ST. TAMMANY PARISH
SLIDELL ADMINISTRATIVE COMPLEX
520 OLD SPANISH TRAIL
SLIDELL, LOUISIANA

RENOVATION PROJECT

CONTRACT SET- 10/10/07

1ST FLOOR DEMOLITION PLAN

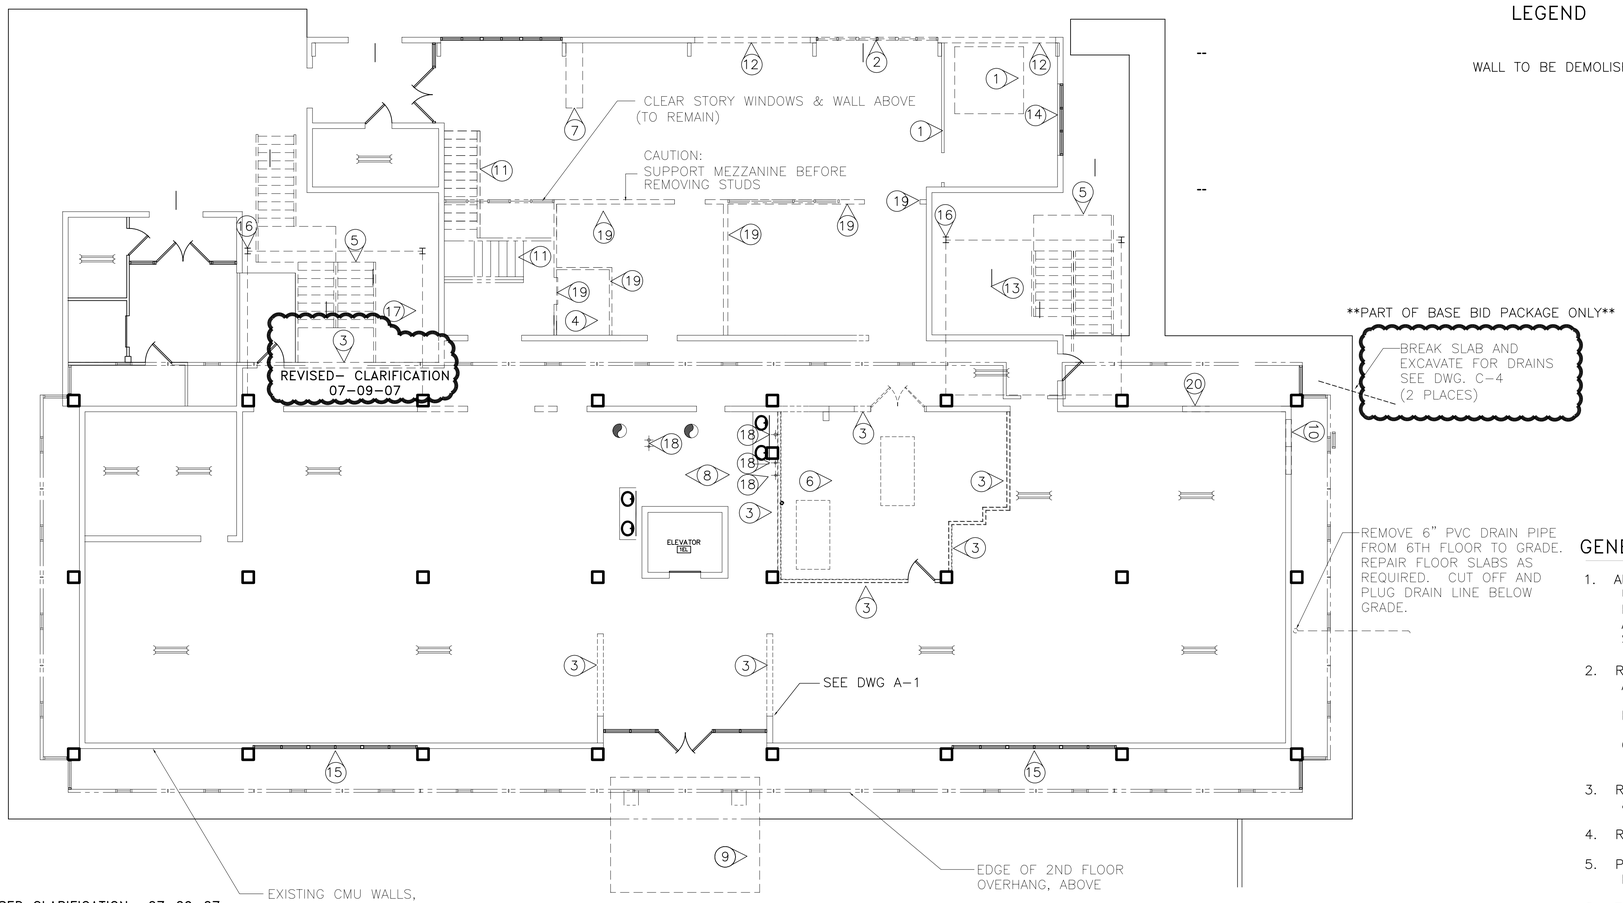
REVISED CLARIFICATION– 07–09–07

THE REVISED CLARIFICATION REFERENCED BY ADDENDUM 4 D–1.PDF INCORRECTLY DEPICTED ITS INTENT. THE WALL IN THE REVISION CLOUD IS THE WALL THAT IS TO BE REMOVED.
